TRANS/WP.29/GRE/2002/20
28 January 2002

World Forum for Harmonization of Vehicle Regulations (WP.29)

PROPOSAL FOR DRAFT AMENDMENTS TO REGULATION No. 48

Transmitted by the Expert from the Working Party "Brussels 1952" (GTB)

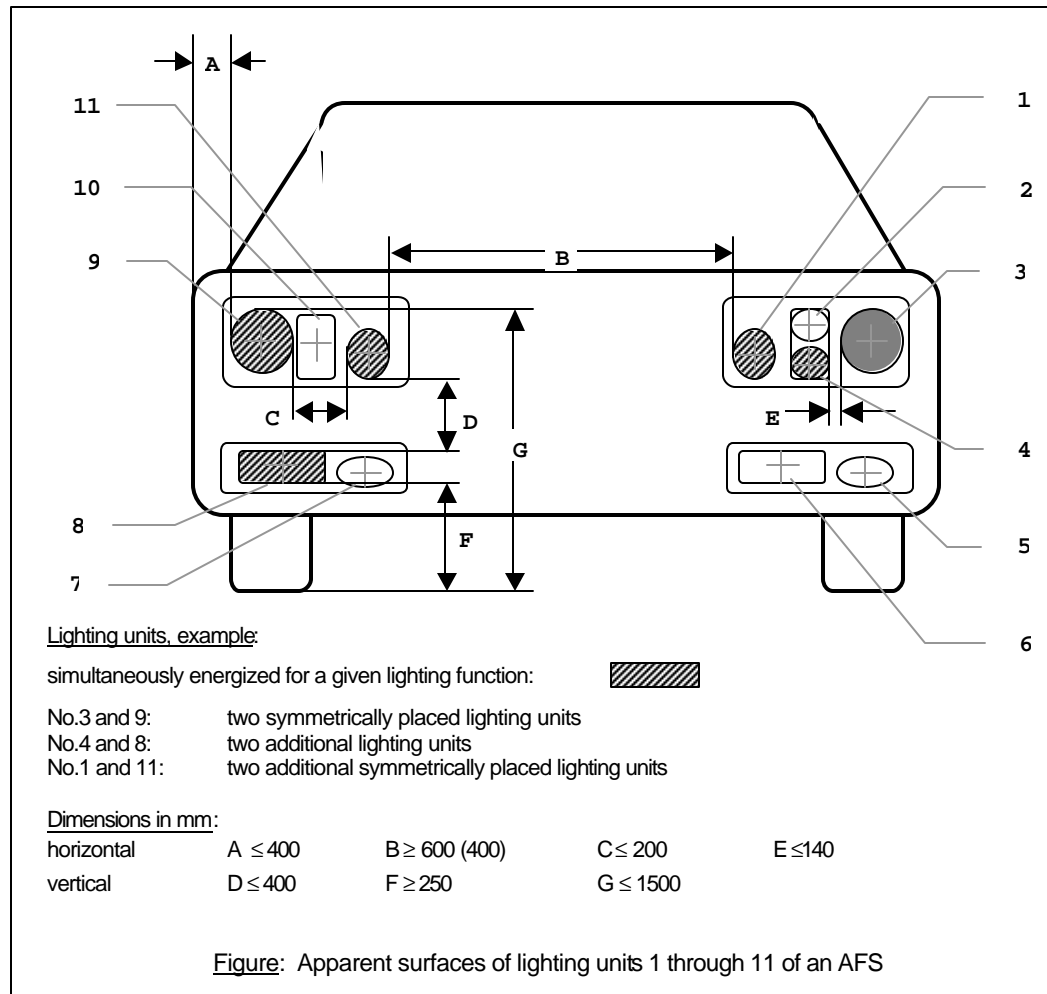
6.20.4.1.2. Additional lighting units, if any, on either side of the vehicle shall be positioned at a distance not exceeding 140 mm 7/ in horizontal direction (E in the figure) and 400 mm in vertical direction above or below (D in the figure) from the nearest lighting unit;

6.20.4.1.3. None of the additional lighting units described in paragraph 6.20.4.1.2. above shall be positioned lower than 250 mm (F in the figure) nor higher than 1,500 mm (G in the figure) above the ground;

the outer edge of the apparent surface of at least one lighting unit on each side of the vehicle shall not be more than 400 mm from the extreme outer edge of the vehicle (A in the figure); and,

the distance between the inner edges of the apparent surfaces of the lighting units on the right and left hand side of the vehicle

(B in the figure) shall be not less than 600 mm, or, except for category M₁ and N₁ vehicles not less than 400 mm when the overall width of the vehicle is less than 1,300 mm.

7/ In case of additional "two symmetrically placed lighting units" the horizontal distance may be 200 mm (CC in the figure).
